**CHARLOTTE DOUGLAS INTERNATIONAL AIRPORT  
CHARLOTTE, NORTH CAROLINA**

**ADDENDUM NO. 2**

**NORTH END AROUND TAXIWAY (NEAT)  
OVERLOOK RELOCATION**

**CLT PROJECT NO. AVIA 23-50  
ADDENDUM DATE: MAY 25, 2023**

FILE NAME: SCALE: 1"=20'

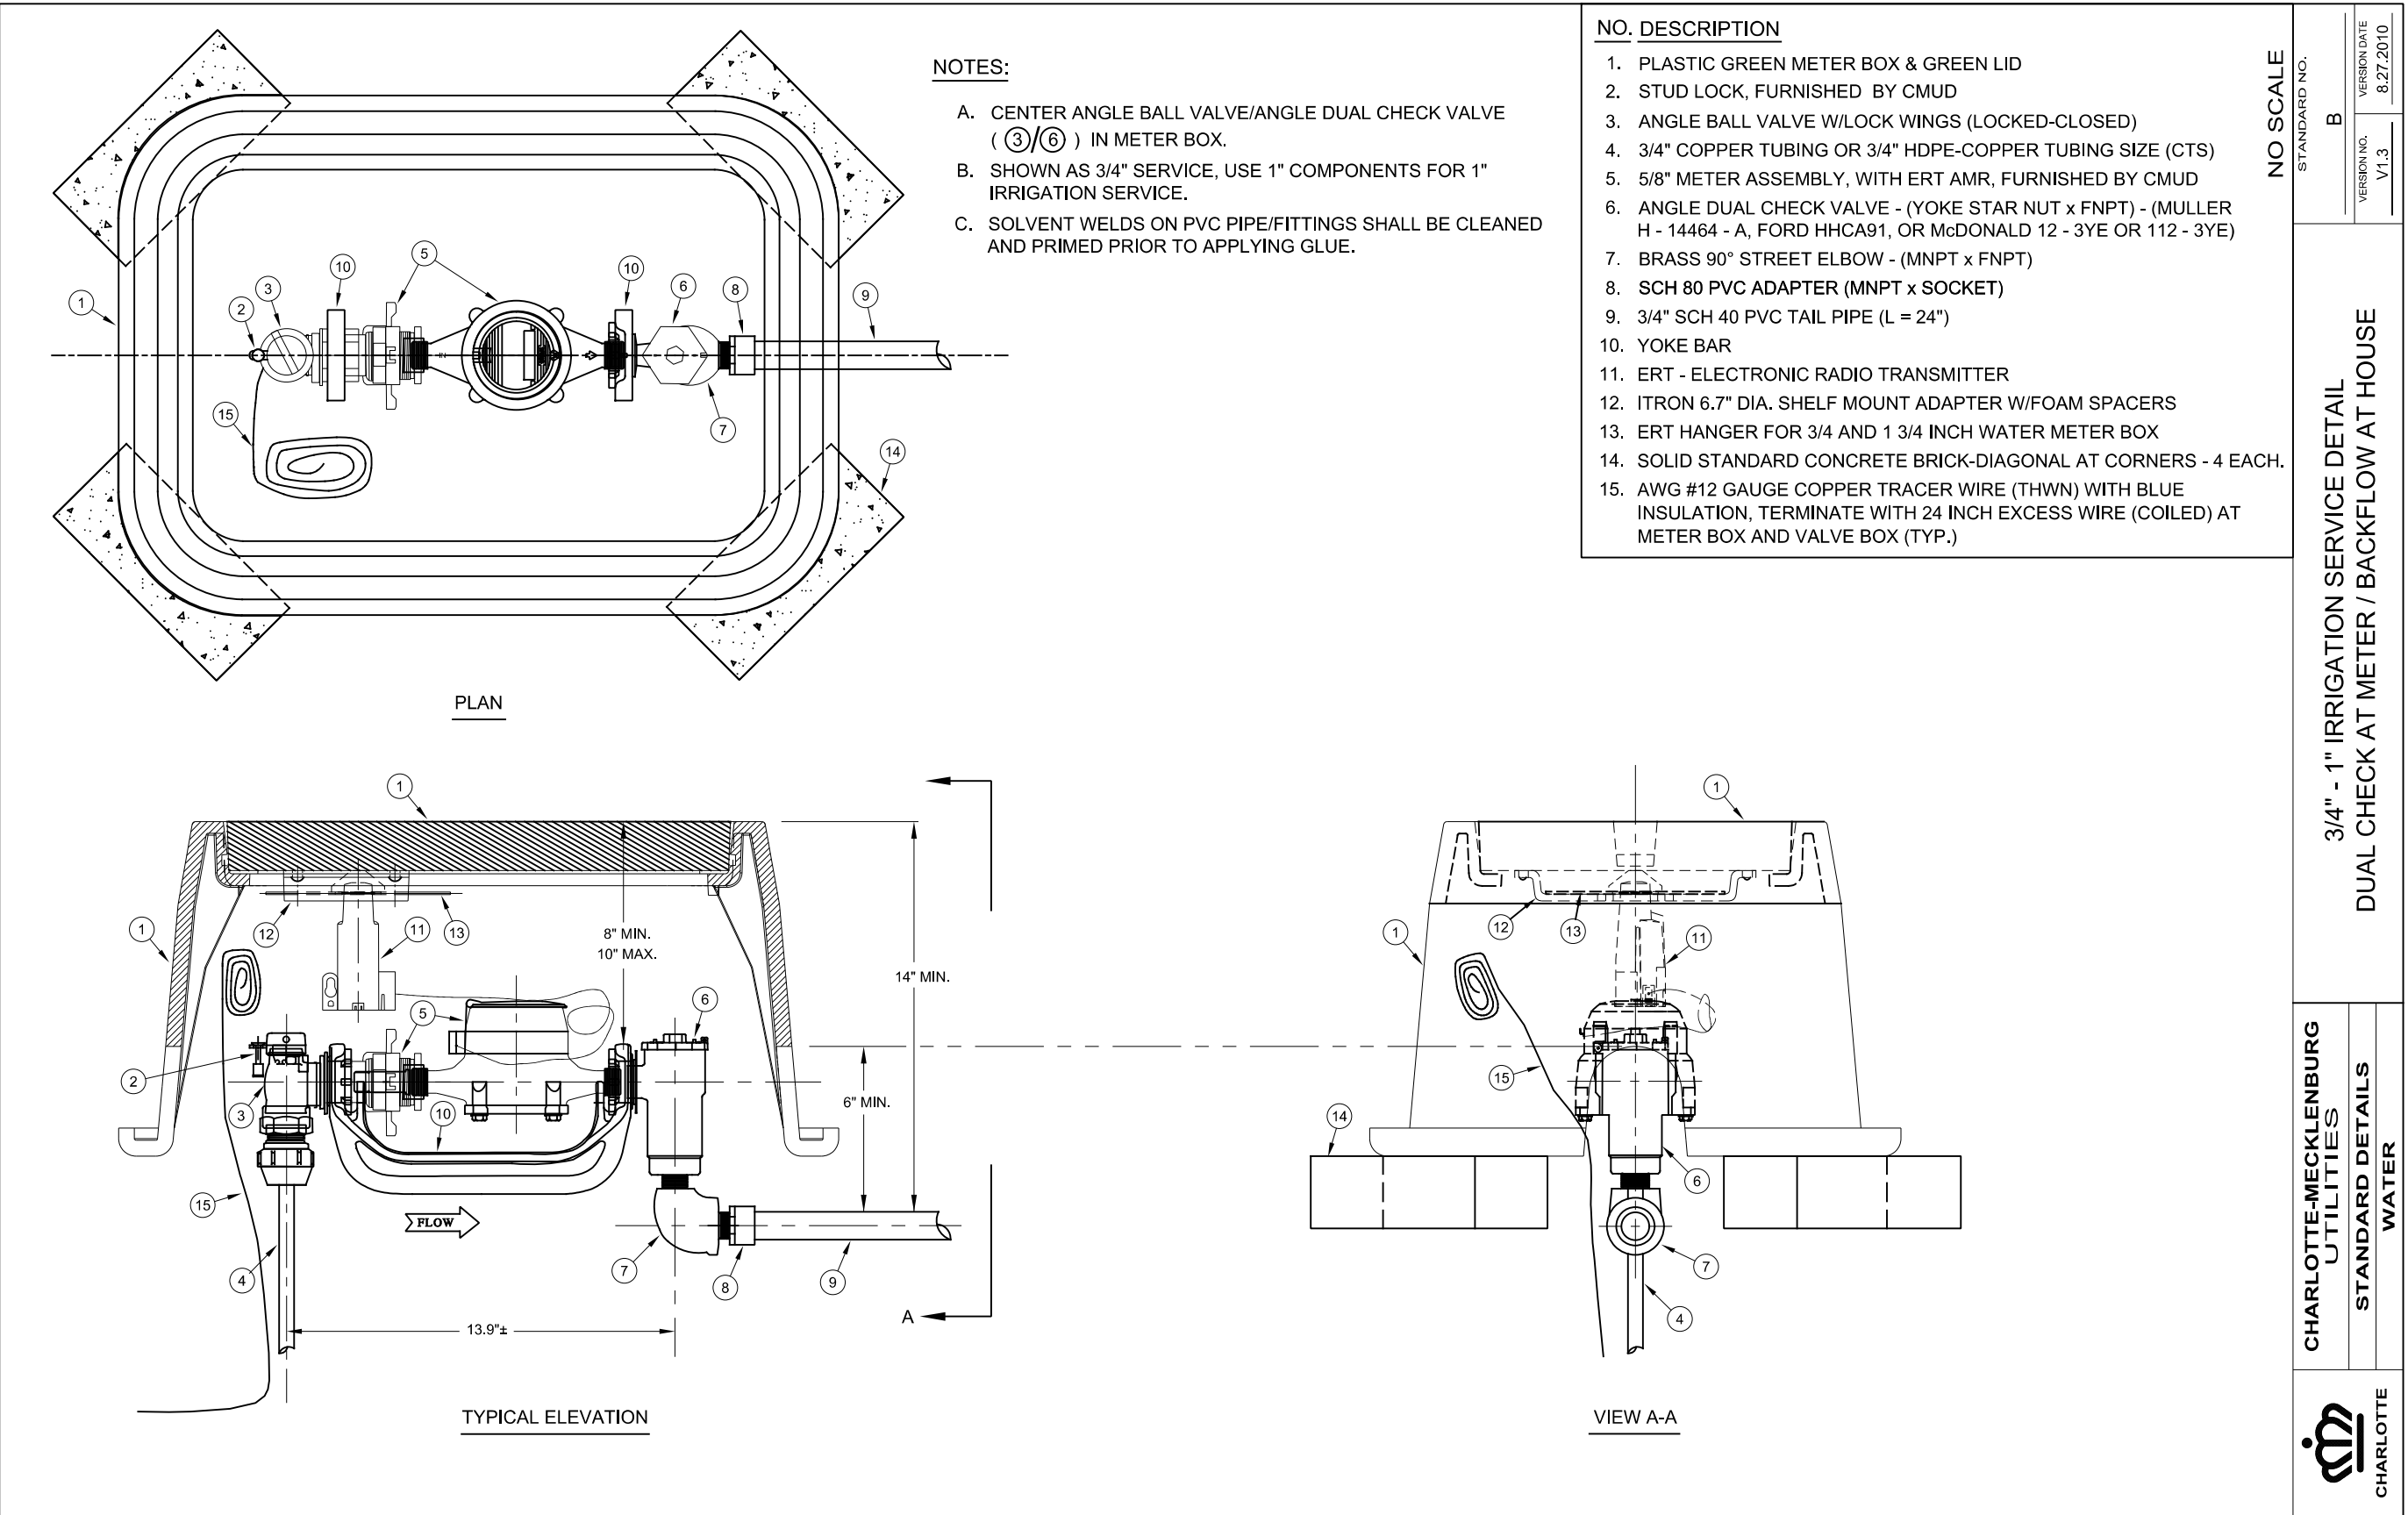
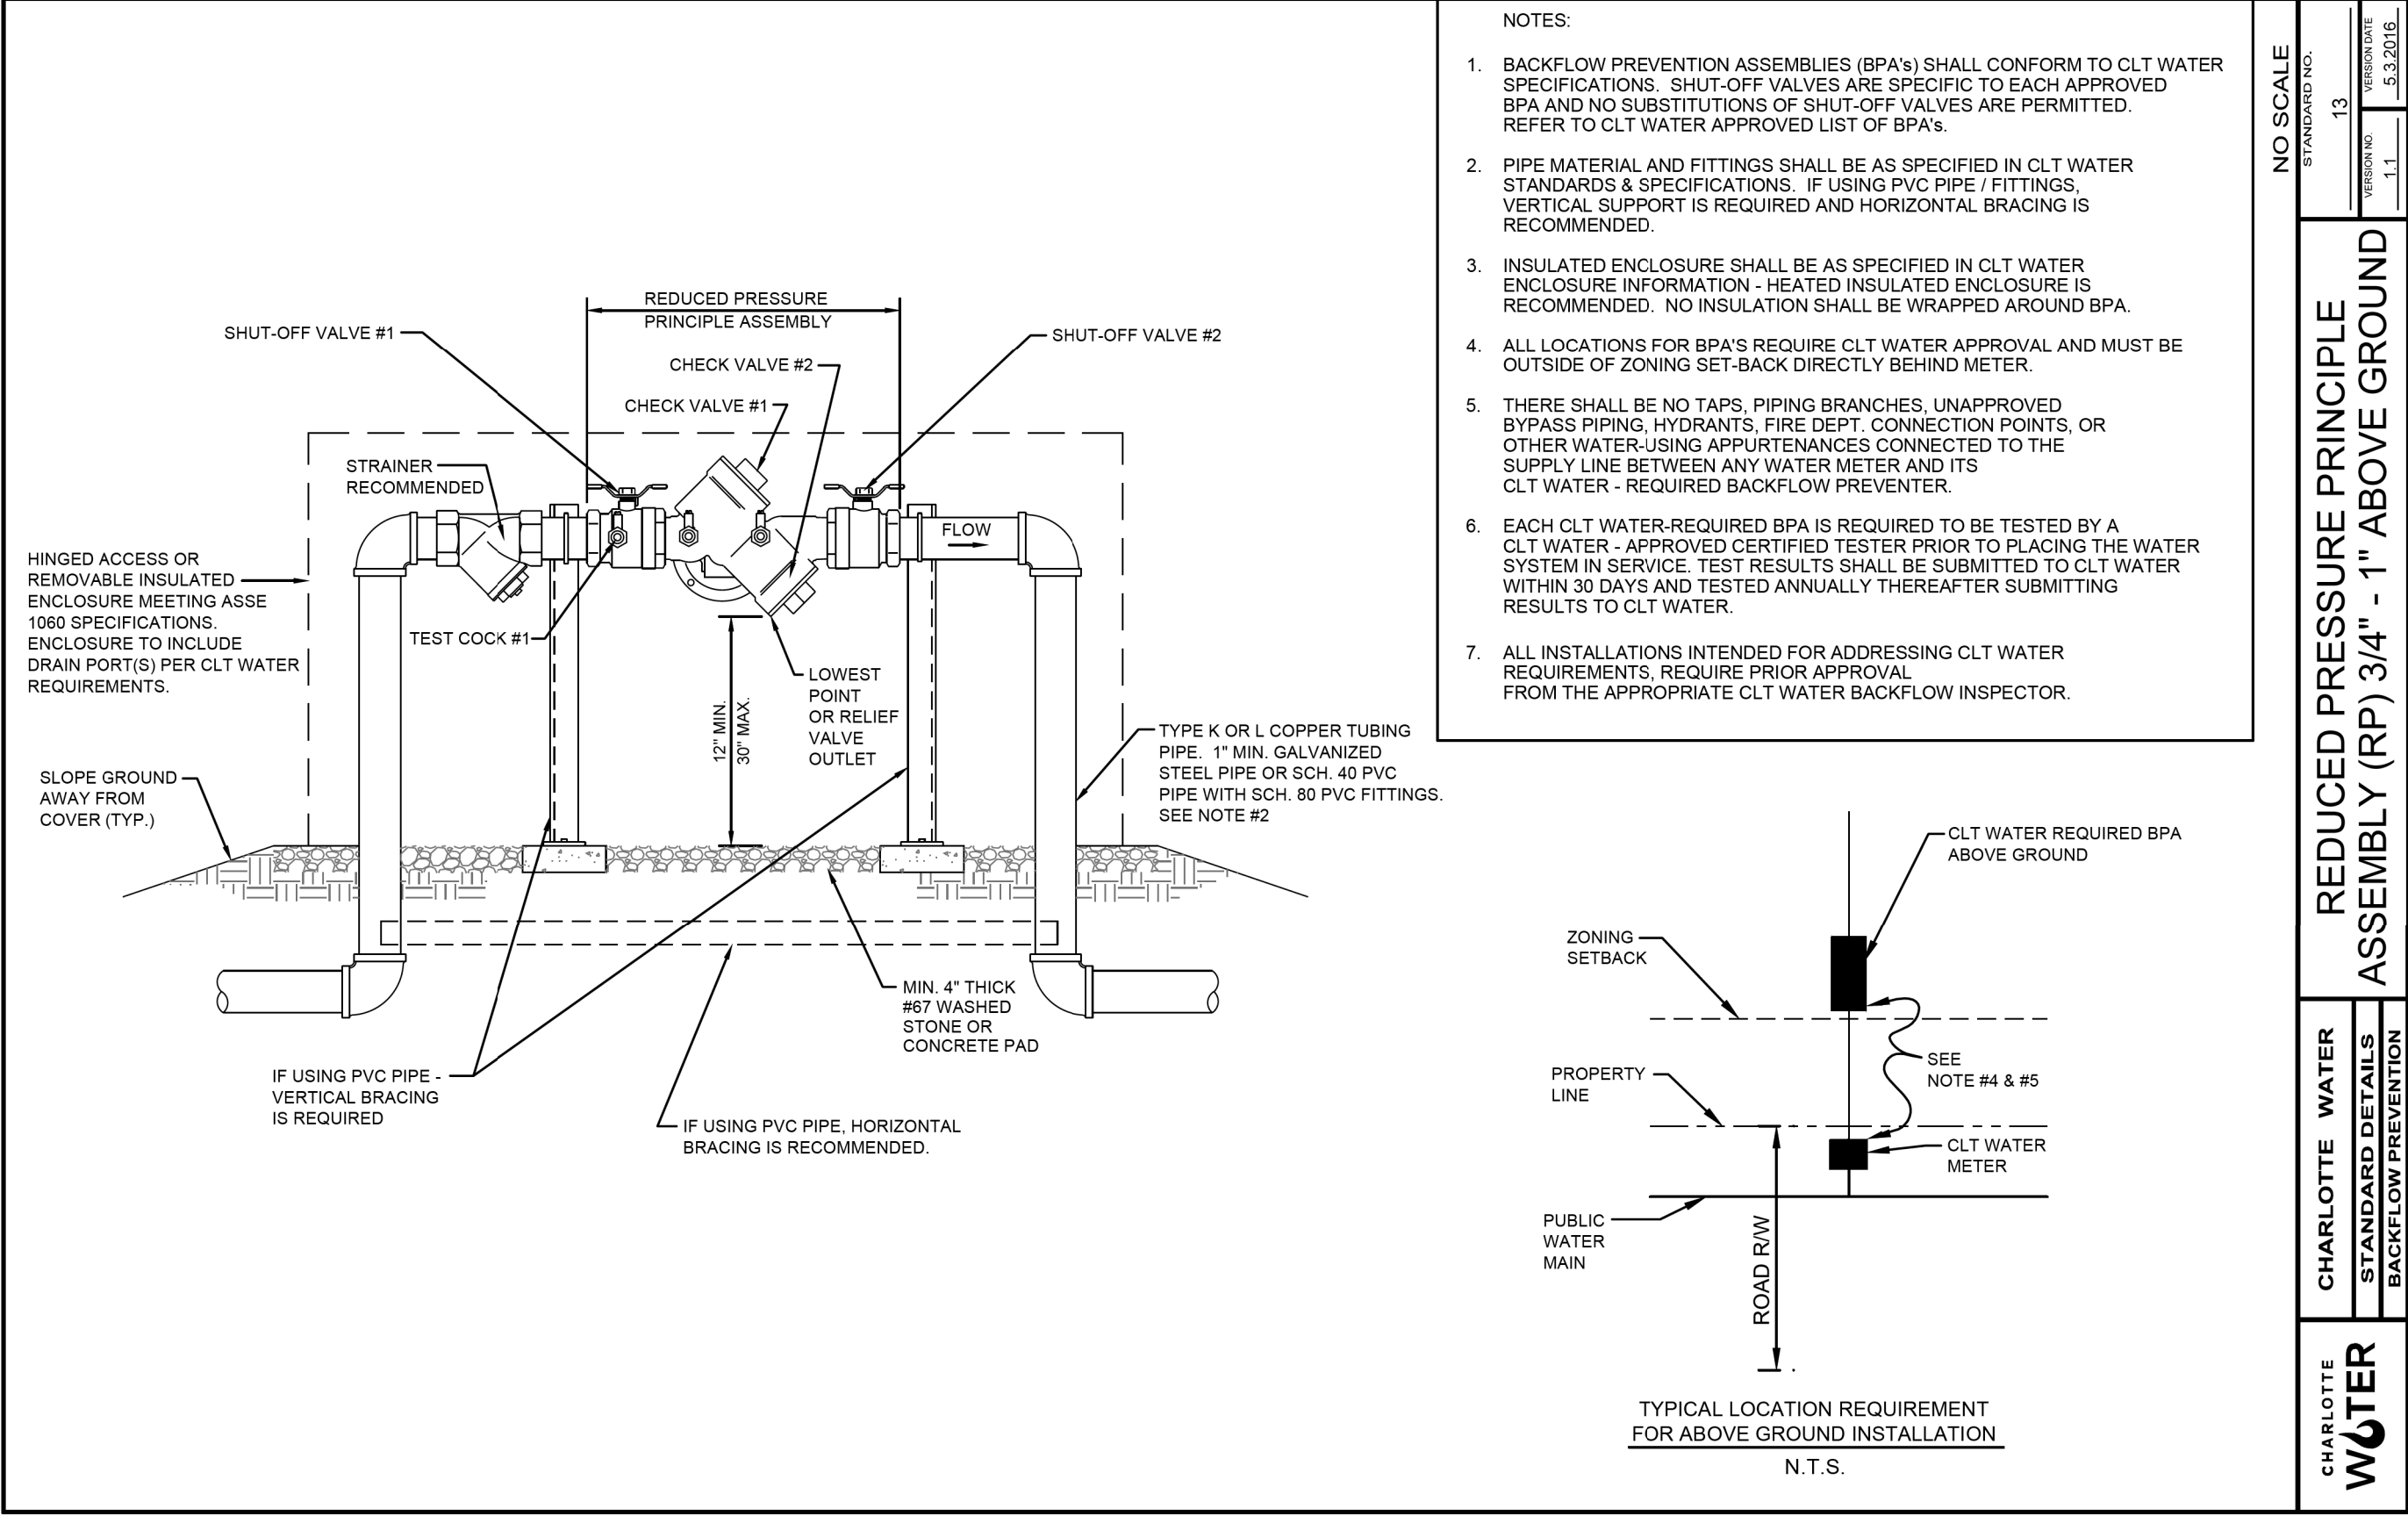
REVISIONS		DATE
1	ADDENDUM NO. 1 - REVISED AIRCRAFT DISPLAY AREA	05/15/2023
2	ADDENDUM NO. 2 - REVISED DUKE SUPPLIED PULLBOX DESIGN	05/25/2023
3		
4		
5

- NOTES:
- ALL LIGHT POLES/BOLLARDS ARE OFFSET 1' FROM EDGE OF NEAREST SIDEWALK UNLESS OTHERWISE NOTED.
  - BOLLARD LIGHTS SHALL BE TIED FROM ELECTRICAL PANEL TO PHOTOCELL FOR DUSK TO DAWN CONTROL. (SEE SHEET E-1 FOR DETAILS)
  - ALL ROADWAY/PEDESTRIAN LIGHT POLES SHALL HAVE 1-3" CONDUIT FROM LIGHT POLE TO NEAREST ELECTRICAL PULLBOX/JUNCTION BOX.
  - BOLLARD LIGHTS SHALL BE INSTALLED ON A CONCRETE BASE WITHIN THE SIDEWALK. (SEE SHEET 3A-9 FOR DETAIL)
  - CONTRACTOR SHALL INSTALL ALL DUKE SUPPLIED PULLBOXES. COORDINATE WITH YTULO EVANS 803-835-7945 TWO (2) WEEKS IN ADVANCE FOR DELIVERY OF PULLBOXES.
